150 E ROSEMARY STREET LAB/OFFICE BUILDING

TCAB Review

28 September 2021

VHB RECOMMENDATIONS – E ROSEMARY ST DRIVEWAY

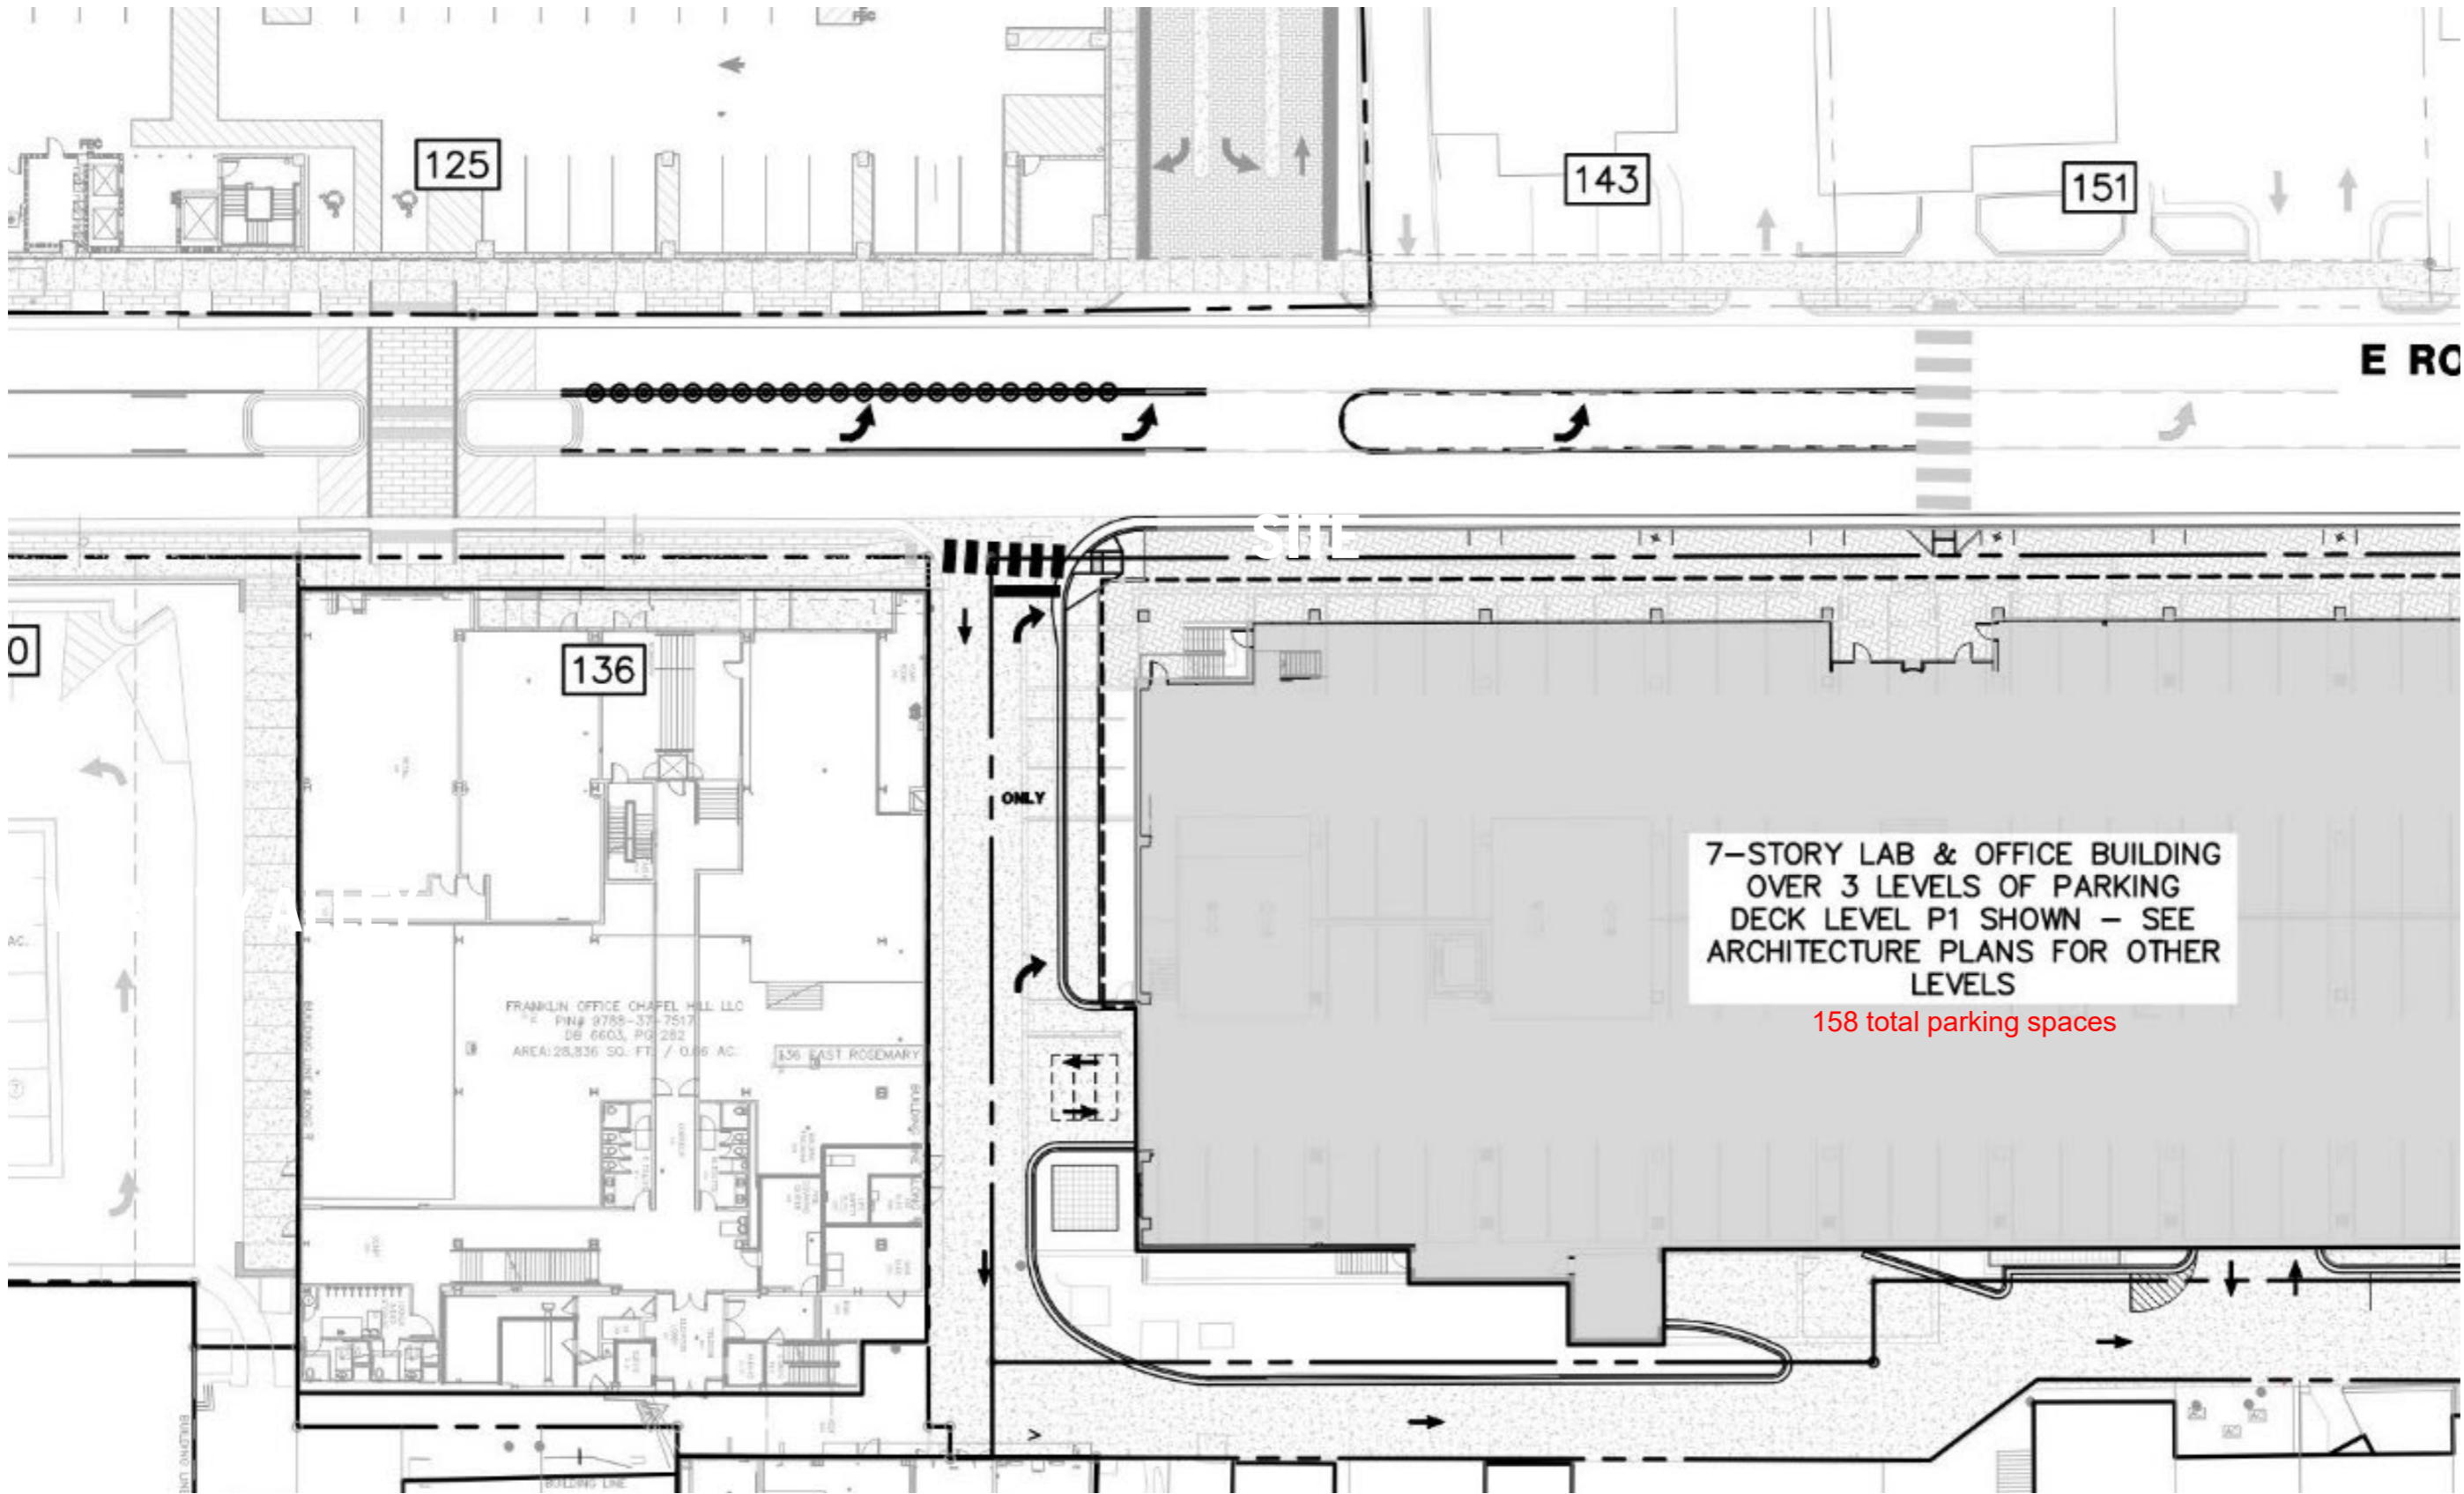
- 1) Though no specific office building site plan was complete at the time of the TIA, it was assumed that access would be provided along the site frontage and, as no comments were made at the time of recommendations and TIA submittal, I'm wondering why at this point would they choose to locate all inbound access at the current alley when the TIA recommendation was for an access point much further away from the E. Rosemary Deck access – particularly if it was known that the E. Rosemary Access was going to be the primary access point for that deck?

- 2) We had assumed 200 office building parking deck spaces in the TIA and the interaction of those with Grubb leased spaces in the E. Rosemary Deck has effects on trip generation/distribution and assignment – for both the E. Rosemary Deck and the office building deck parking. They are now showing 170 spaces. Has the allotment of leased spaces in the E. Rosemary Deck changed as well? We need to know this because we may have to redo all the scenario volume development assumptions and not just those related to the office building.

- 3) I see they have an exit onto Henderson St now? Is that for office building traffic as well as post office/existing alley traffic? I see no other access points for traffic other than this one and the full access point on E. Rosemary at the existing alley – is that correct?

- 4) I see they are reporting 228,000 SF of office/lab space. We had assumed 200,000 SF of space in the original TIA. Unless they have specific breakouts of office and lab space, I'd recommend updating the trip gen and keeping it conservative by using just office space as the generating variable.

- 5) They are indicating 3 levels of parking – which I assume are all internally connected but how many spaces are on each level and are they going to have specific space assignments or is it general open parking? This may have an implication on exiting traffic patterns and portioning of trip distributions if there are 2 potential ways out now.

Due to the building programming and configuration of the deck levels below grade, creating a drive connection within the building's E. Rosemary St. façade proved to be difficult from a design perspective. Also, leaving the one-way alley connection to E. Rosemary just east of the building would take significant usable area away from the Town Green we have been asked to create in this area and would disconnect the Town Green from the building – the opposite of what we are trying to accomplish. This is the reason the one-way alley connection is proposed on Henderson St. We recognize that left-turn conflicts would be an issue on E. Rosemary St. given the originally proposed driveway configuration, so we have modified the E. Rosemary driveway such that it will function as a right-in/right-out driveway and are proposing channelization and pavement markings to aid in its function.

We are currently proposing 158 total parking spaces in the deck below the office building.

Yes, the intent is for the Henderson St. exit to be used by the office building traffic and the post office/existing alley traffic. This and the proposed RIRO driveway at E. Rosemary St. are the only proposed access points.

The current application is for 234,000 sf of office/lab space and 3,000 sf of retail

The lower 2 levels are connected internally and the parking on those levels will be general, open parking. The 3rd level can be accessed only from the alley entrance on the south side of the building and the parking on that level will be assigned.
